Halton District School Board

Addendum No. 4

RFT 23-007 Oakville # 3 Elementary School and Child Care Facility

ADDENDUM NO. 4 (HAA Addendum #2)

1 LIBRARY 209 - C
 SKA-3 SCALE: 1 : 75

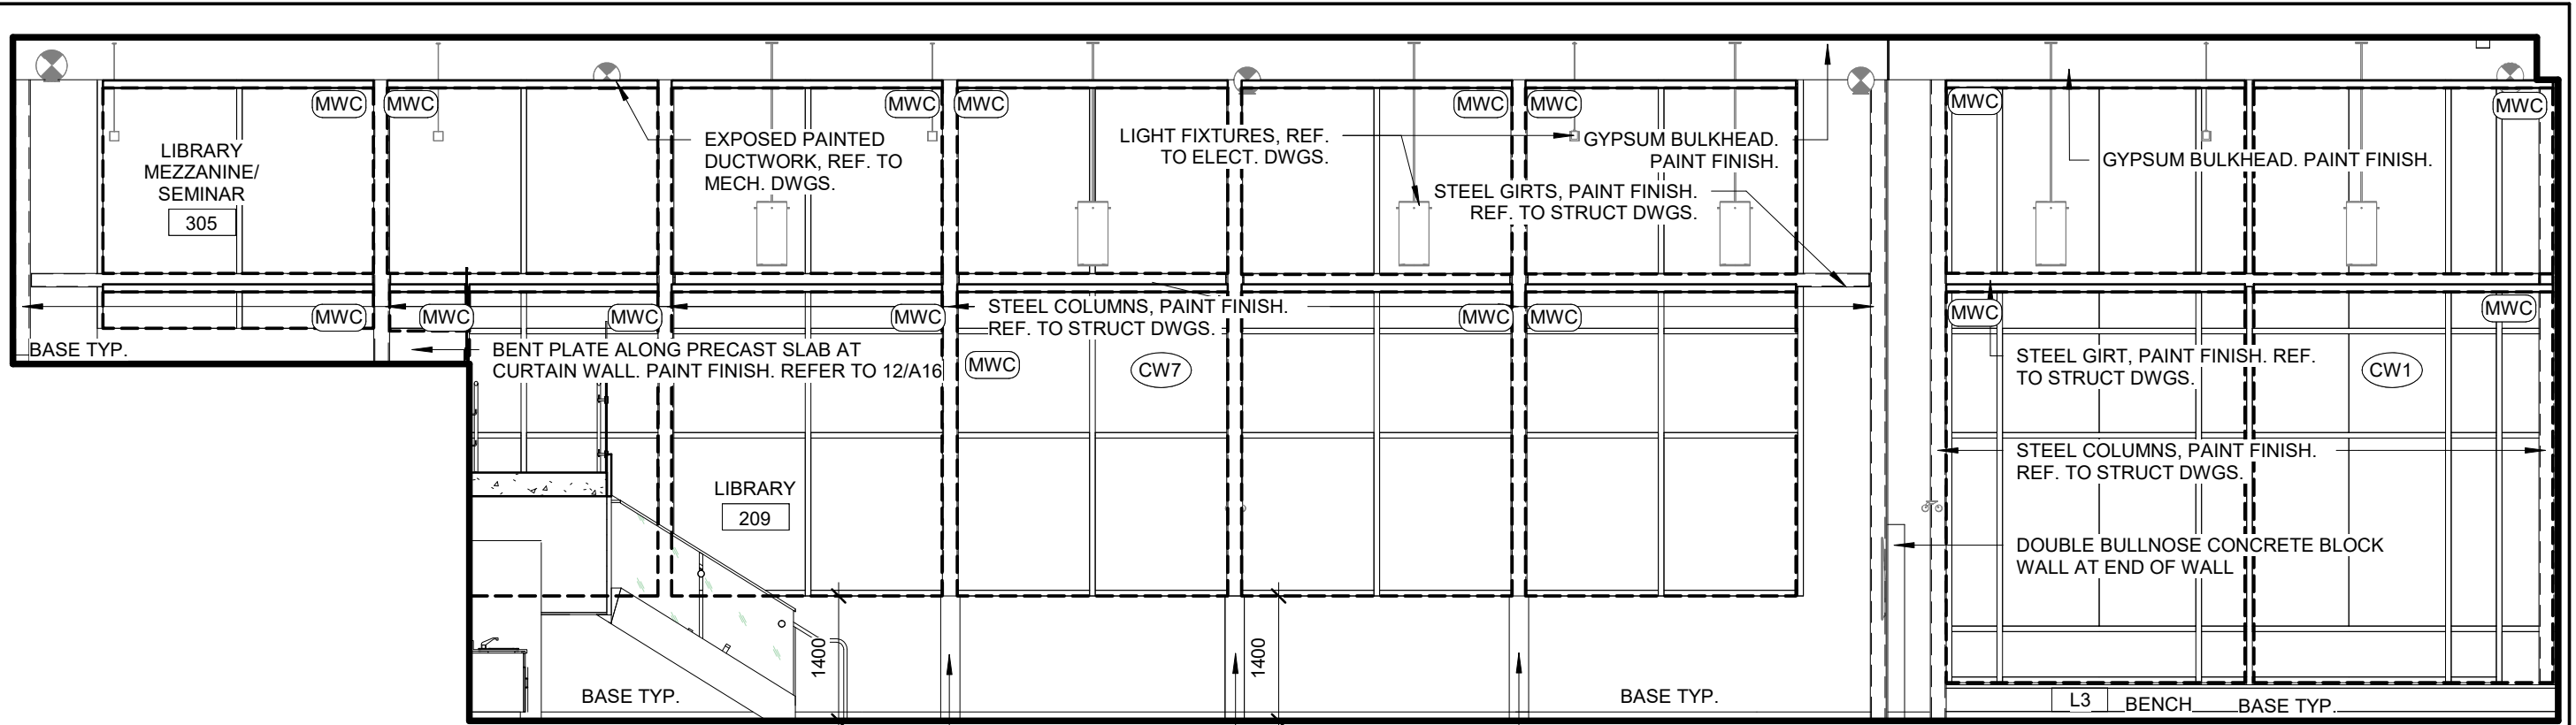
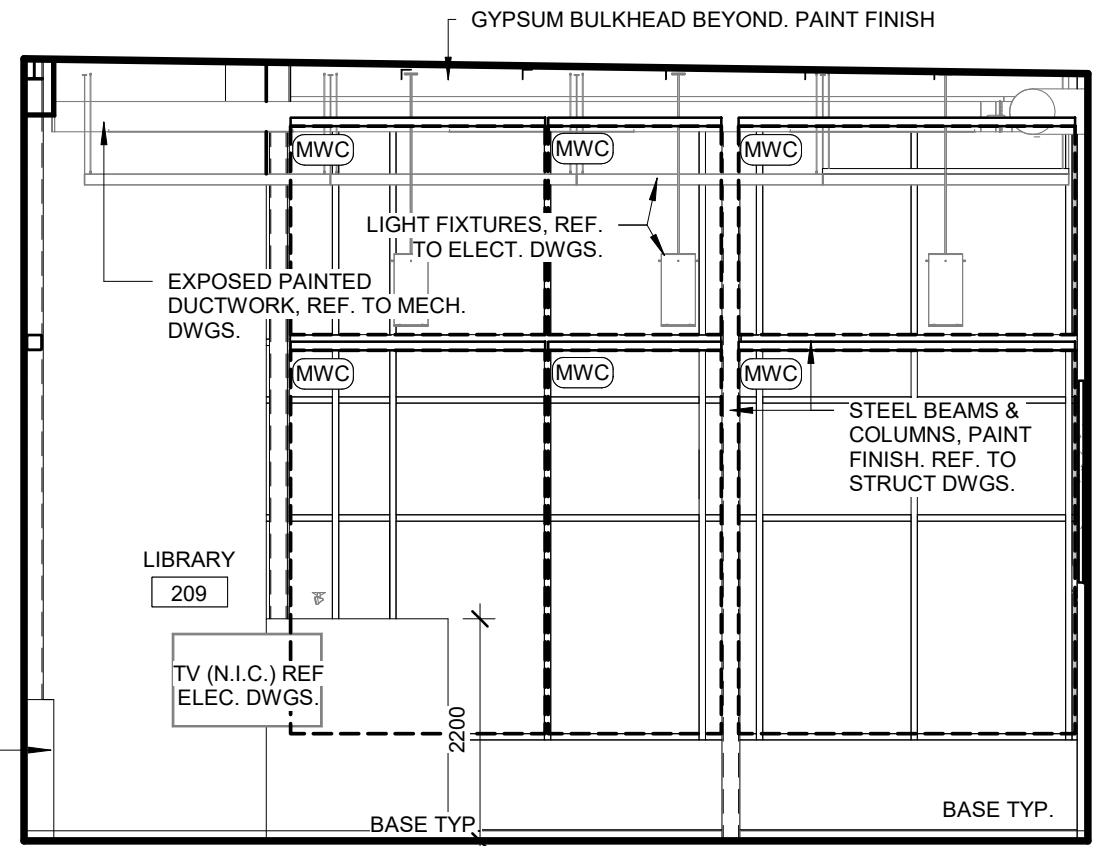
.1 REVISE Interior Elevations 6 & 7/A19 as per SKA-03 attached herein to include for Motorized Window Shades tag "MWS" as shown. Coordinate with electrical drawings.

MOTORIZED WINDOW COVERS IN LIBRARY

PROVIDE FRONT & TOP FILLER PANELS TYP (1400mm HIGH). CUSTOM CUT TOP PANELS TO FIT SNUG AROUND COLUMN.

PROVIDE FRONT & TOP FILLER PANELS TYP (1400mm HIGH). CUSTOM CUT TOP PANELS TO FIT SNUG AROUND COLUMN. REFER TO 26/A17

OAKVILLE #3
(REFERENCE DRAWING
M602)

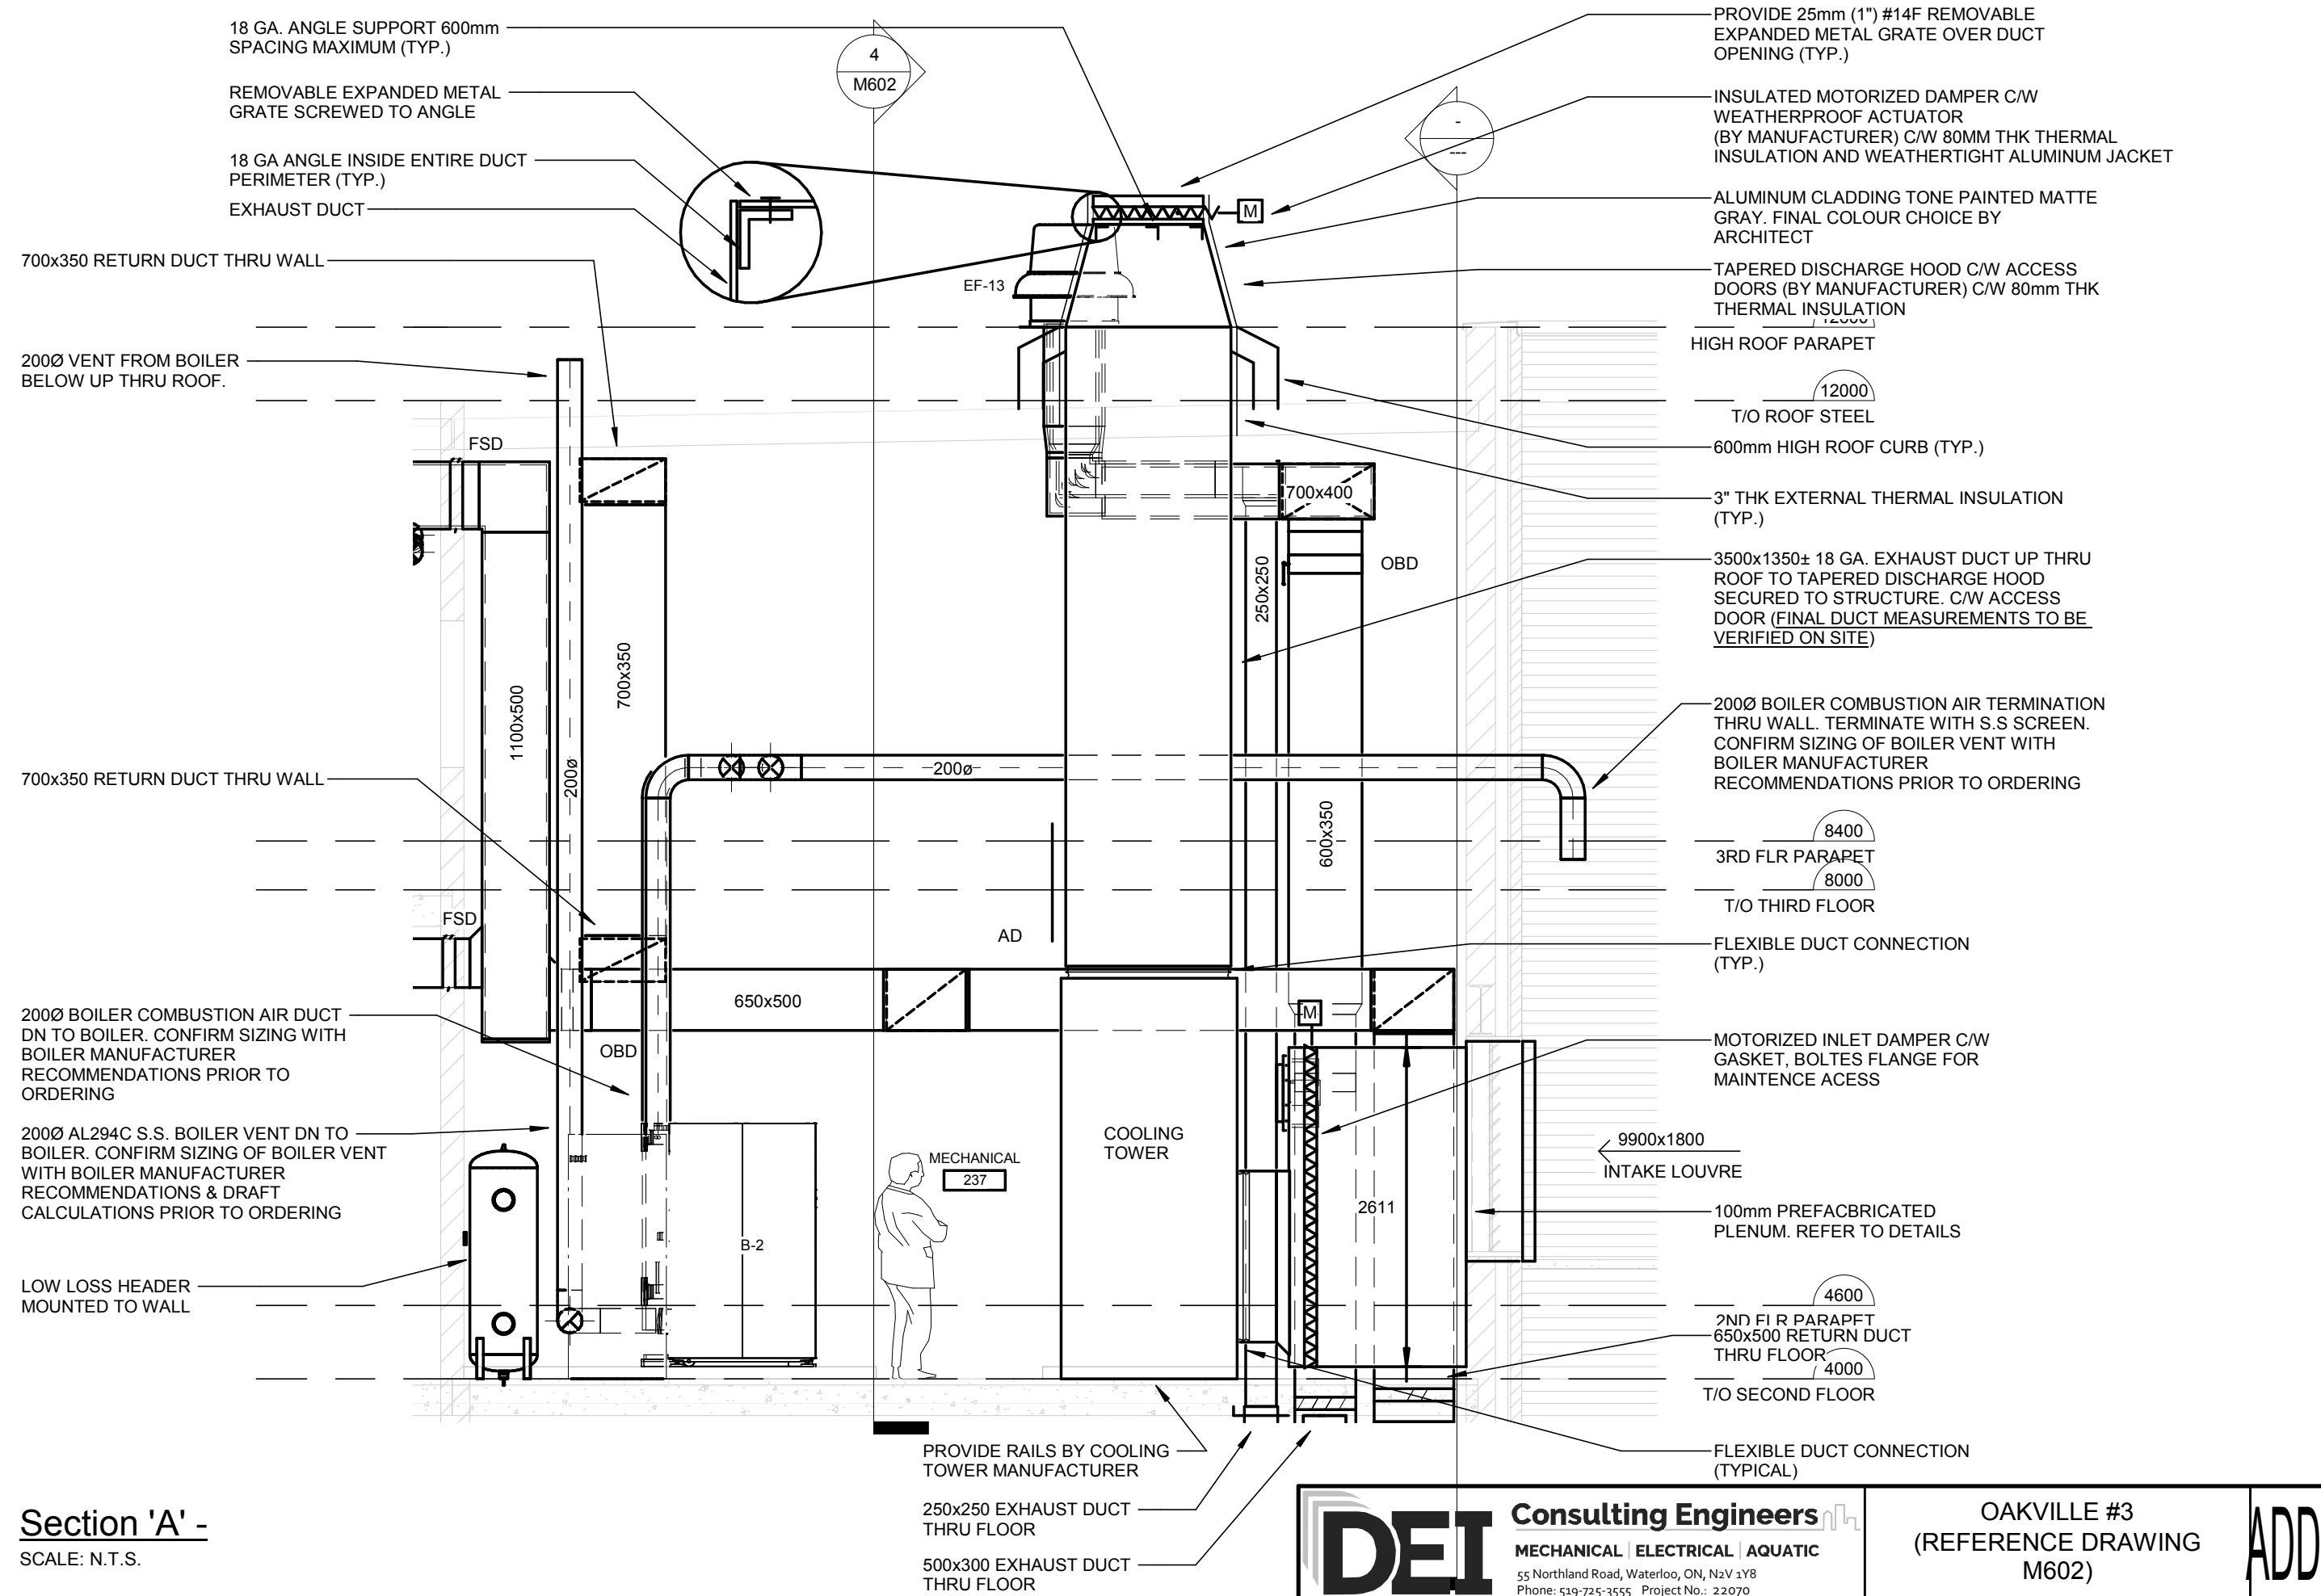
- .4 Refer to attached sketch AD01-M01 for revised cooling tower discharge to be complete with roof mounted tapered discharge. Mechanical contractor to provide suitable discharge plenum between cooling tower and tapered discharge hood complete with flex connection and access doors.
